# LiDAR Quality Assessment Report

MO\_StLouis\_2012

St. Louis City and County, Collected January 29&30 and February 1, 2012 (Part of Delivery 2 of 4 for the MO Grand Project)

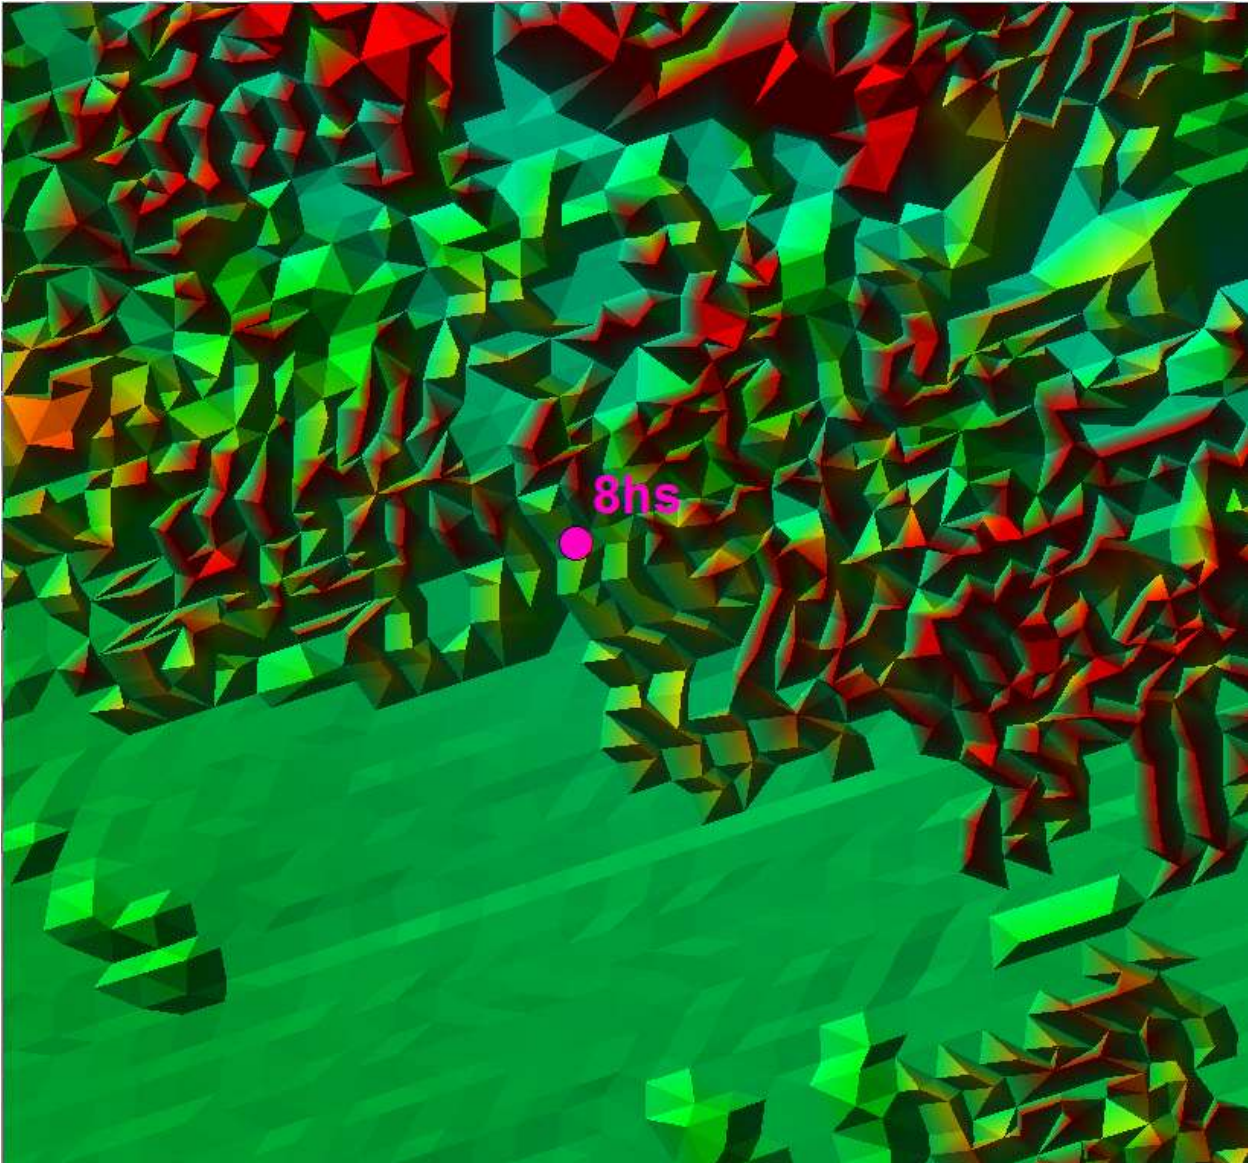
The FVA of the Swath LAS Data is 62.3 meters (NSSDA, 95% Confidence Interval). The swath data needs to be calibrated to meet the FVA requirement of .245 meters or less.

UPDATE: The swath data was calibrated and the FVA is now 0.187 meters at the 95% Confidence Interval; however, one survey point had to be removed due to its location in a forested area. The removed point is "8hs". The image above shows a TIN of the swath LAS points and the location of the removed point. This point had a Z Error of -4.914 meters, which indicates that the survey ground elevation is 4.914 meters less than the swath LAS TIN surface elevation. Swath LAS files have an Unknown Coordinate System.

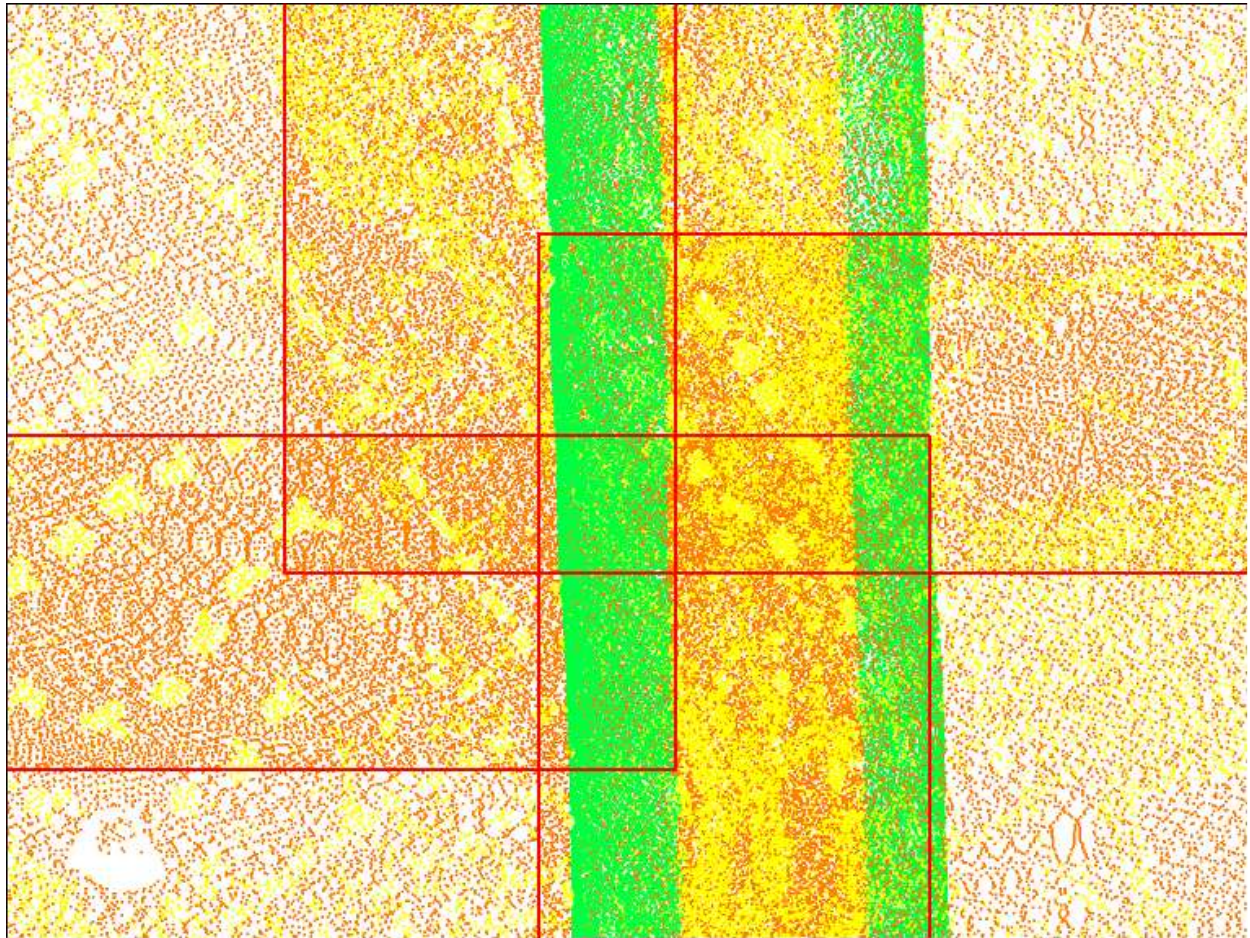
Classified LAS tile files overlap.

UPDATE: Classified LAS tiles no longer overlap.

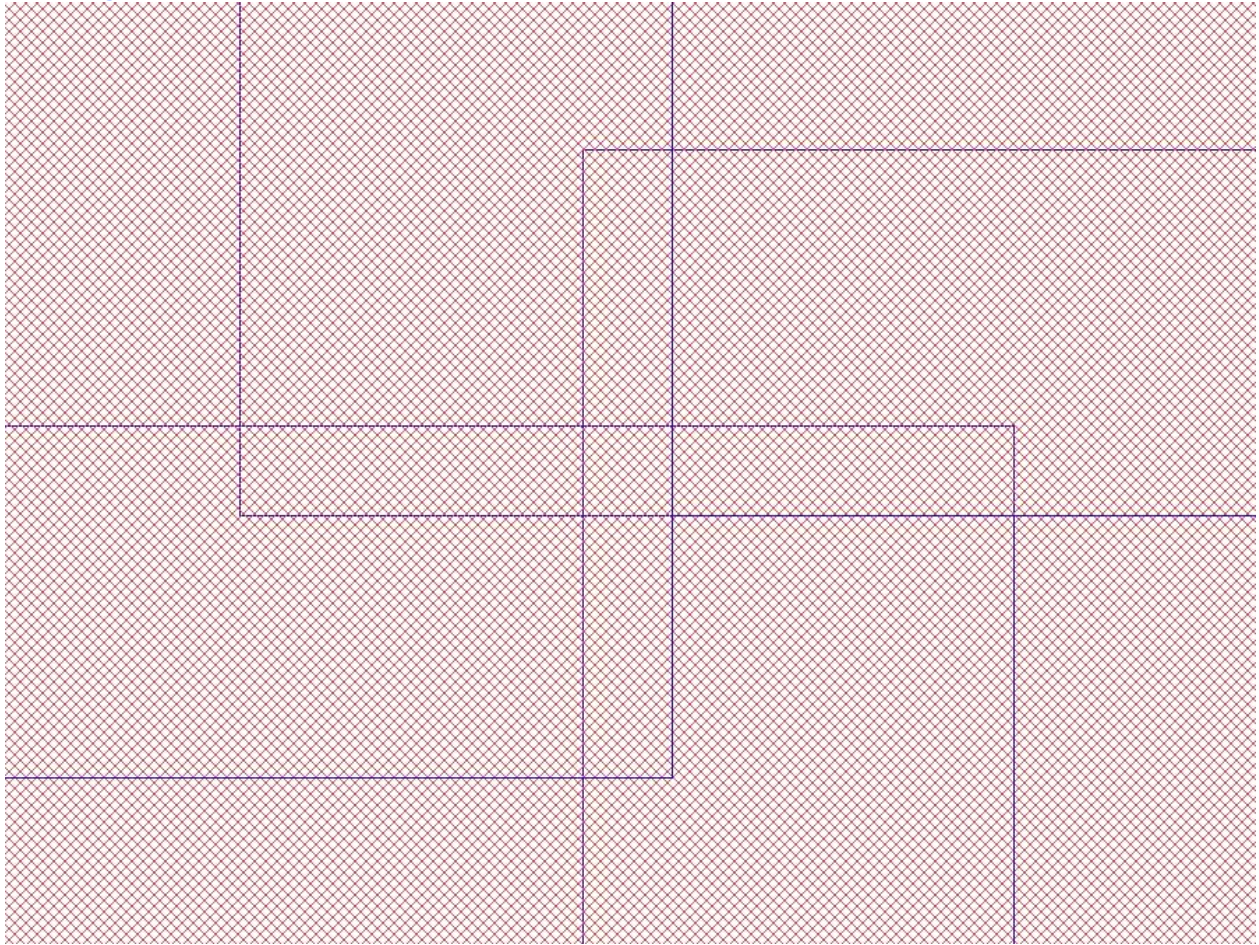
No project tiling scheme was provided. DEM files overlap.

UPDATE: All DEM errors have been corrected, and the DEM tiles no longer overlap.

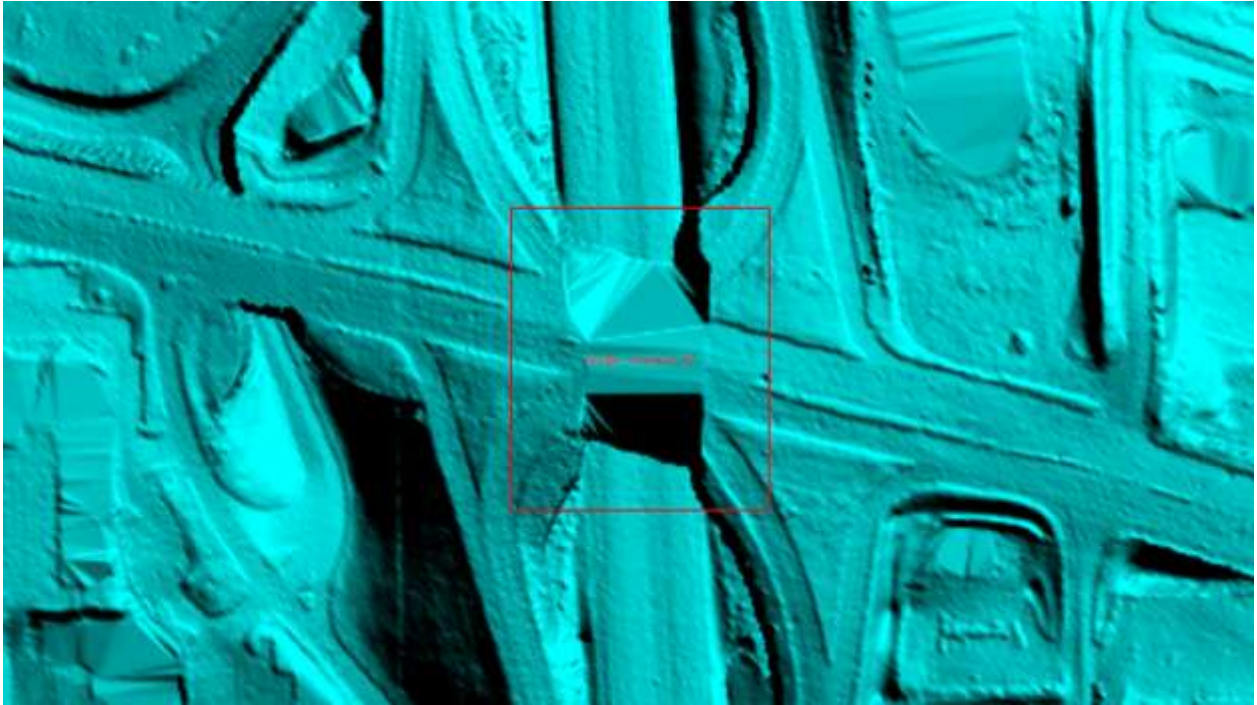
There are a total of five bridges that were not adequately removed. ALL BRIDGES HAVE BEEN REMOVED, WITH THE EXCEPTION OF SEVERAL BRIDGE SADDLES. NO FURTHER ACTION REQUIRED. (10/12/2012)

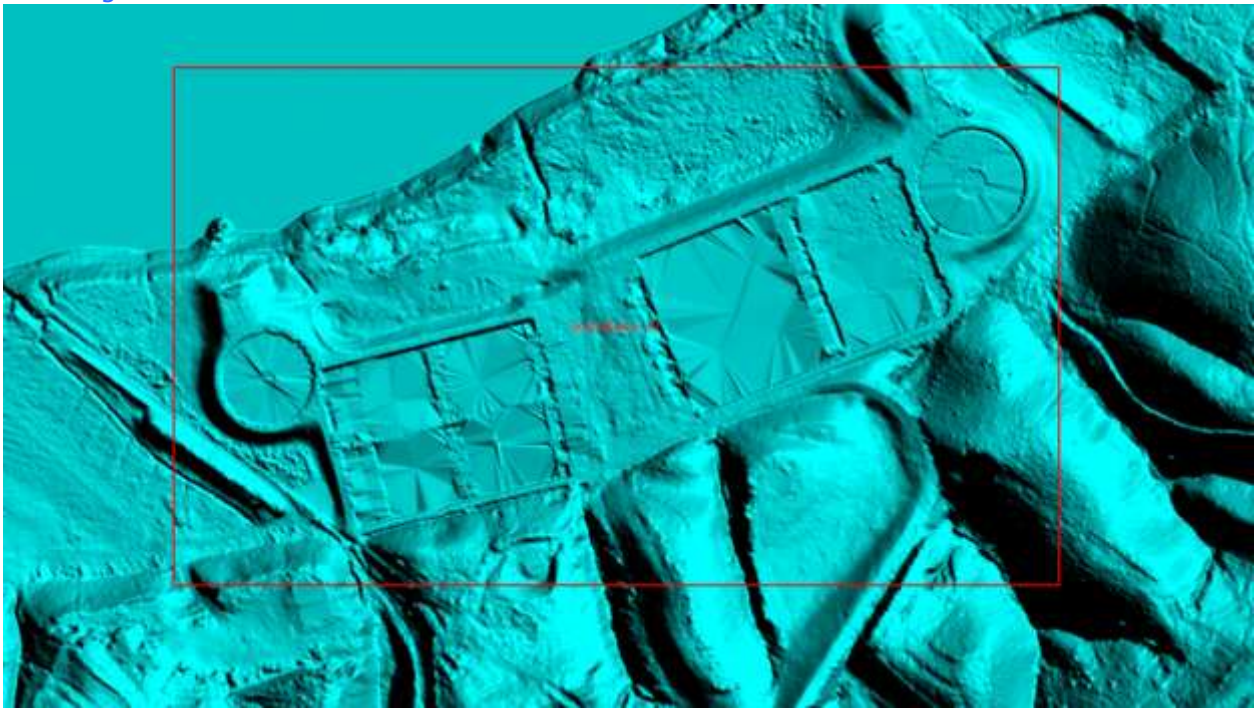
There are ten water bodies that have not been hydroflattened. The majority of the water bodies are water treatment plants, the remaining water bodies are small ponds, greater than 2 acres in size. NINE OF TEN WATER BODIES HAVE BEEN HYDROFLATTENED. NO FURTHER ACTION REQUIRED. (10/12/2012)

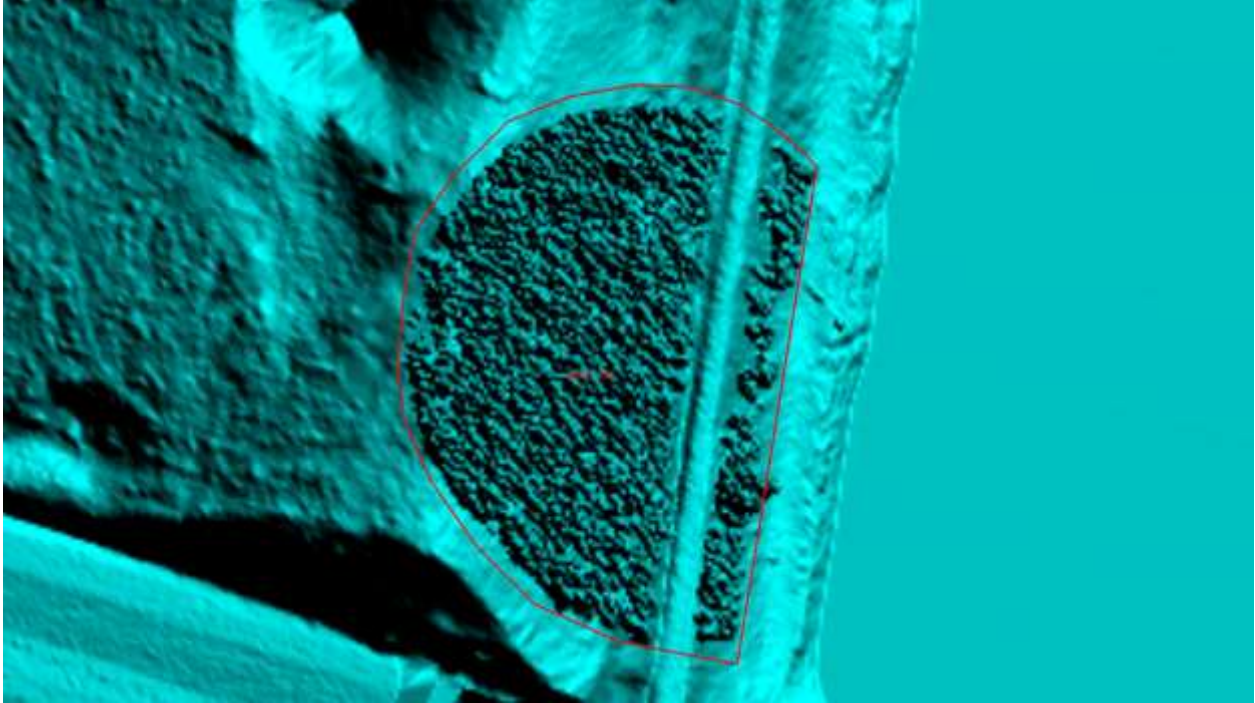
There is one area where lidar returns from trees were misclassified as ground, and were therefore included when the DEM was created. THIS ISSUE HAS BEEN CORRECTED. NO FURTHER ACTION REQUIRED. (10/12/2012)
